**FINDINGS AND RECOMMENDATION
OFFICE OF PLANNING AND ZONING
ANNE ARUNDEL COUNTY, MARYLAND**

CASE NUMBER: 2023-0153-V

REQUEST

The applicant is requesting variances to allow a dwelling addition (2nd story and deck) with less setbacks and buffer than required on property located at 343 Kingsberry Drive in Annapolis.

EXISTING SITE CONDITIONS & RESOURCE MAPPING

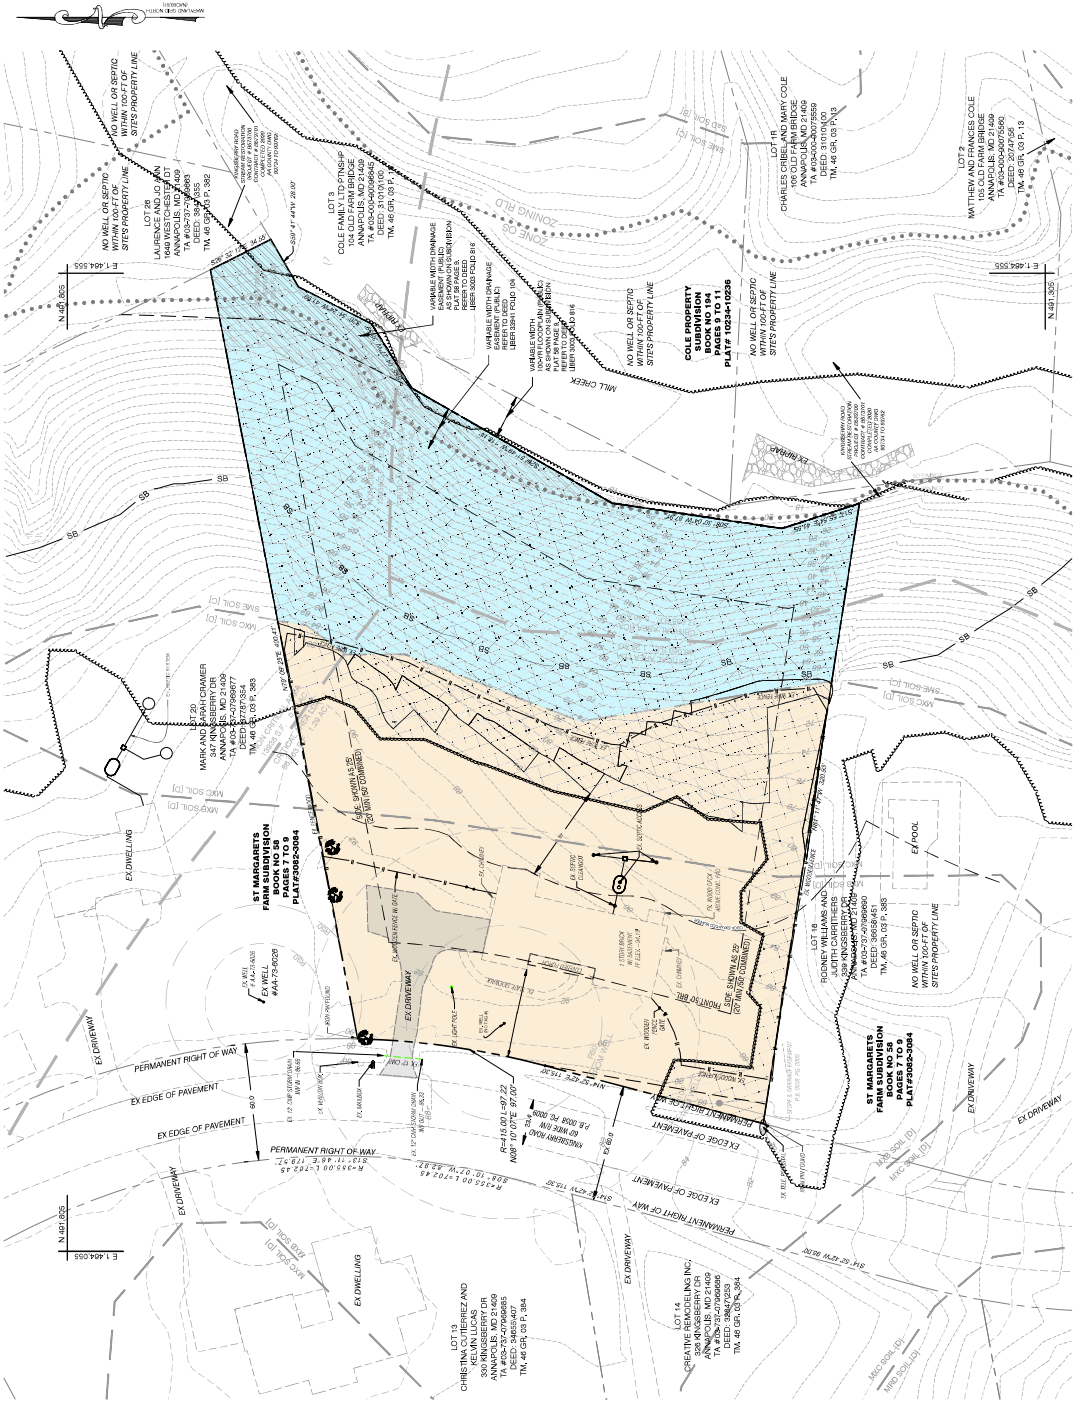
The **Zoning Administration Section** notes that the variance site plan must label the dimensions, height, and number of stories of the proposed structures. While the second story over the existing dwelling is reasonable, the applicant must demonstrate that the long deck meets all of the Critical Area variance standards and that the request is the minimum necessary to afford relief.

3. Show and label clearly the proposed SWM practice (s) on the site plan.
4. A soil boring is required per practice. The suitability, and siting of proposed SWM practices should be reviewed. Soil boring information including verification of the suitability of in-situ soils for infiltration shall be submitted.
